Wisconsin Department of Transportation

Proposal #35: 6685-03-72, WISC 2025055
T Spencer, Pleasant Road
E Br Yellow River Bridge B-37-0477
Loc Str
Marathon County

This is Addendum No. 01, which provides for the following:

Addendum No. 01
ID 6685-03-72
Revised Sheet 37
November 6, 2024

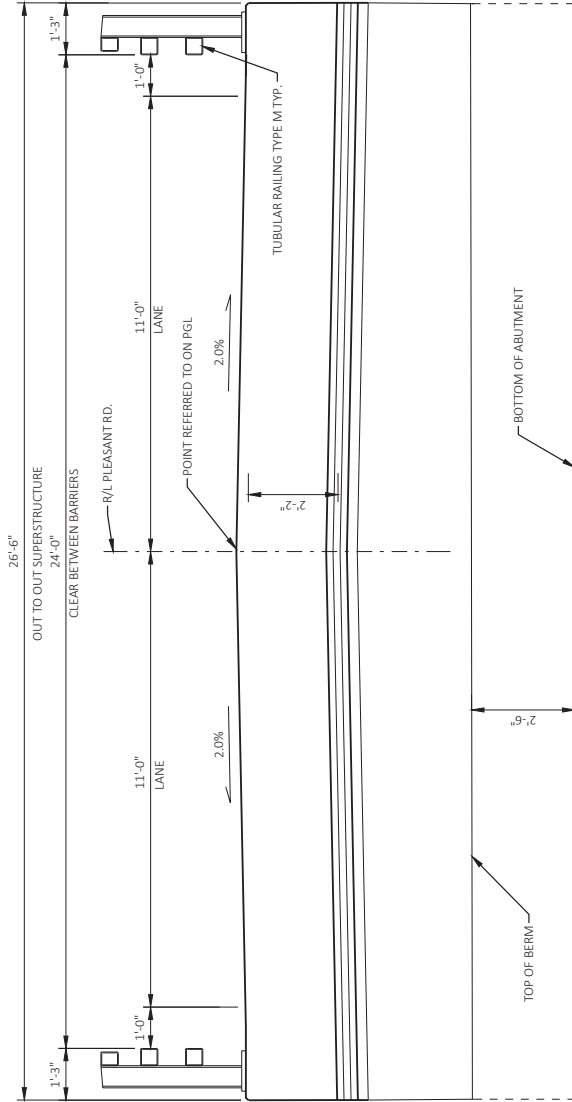
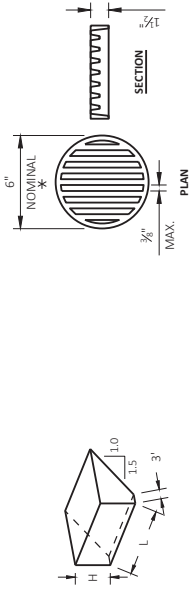
Revised Plan Sheets	
Plan Sheet	Plan Sheet Title (brief description of changes to sheet)
37	Revised quantity of Item 513.4061 Railing Tubular Type M

Revised: 37

513.4061	RAILING TUBULAR TYPE M	LF	-	-	155	155
516.0500	RUBBERIZED MEMBRANE WATERPROOFING	SY	11	11	-	22
550.1100	PILING STEEL HP 10-INCH X42 LB	LF	95	95	-	190
